From: tim lyda <tlyda@tillamookor.gov>
Sent: Friday, January 12, 2018 10:53 AM
To: Abigail Donowho
Subject: Cypress Street Closure

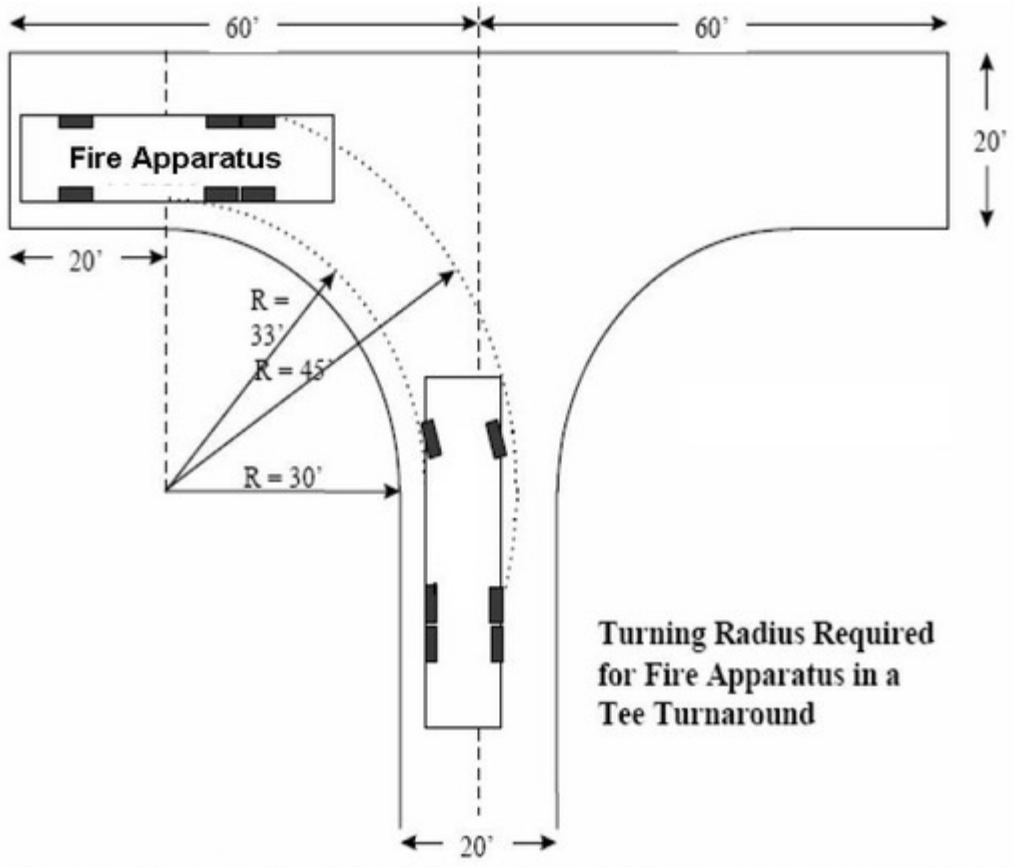
The Fire Department is requiring the hammerhead with a minimum of 120' on the back leg. That will require an additional 40' on the North side of the intersection back towards the garden area of the school. An easement from the property owner will be required to extend the road way North the required 40'.

The Fire Department will be opposing closing the street. They feel they need it for emergency access.

The 20 ft access width is a minimum for use only with an *exclusive* fire department emergency access way. For roadways or public streets, these access widths must be increased. The end length of 60 ft may remain the same, however. Variations of this hammerhead are shown
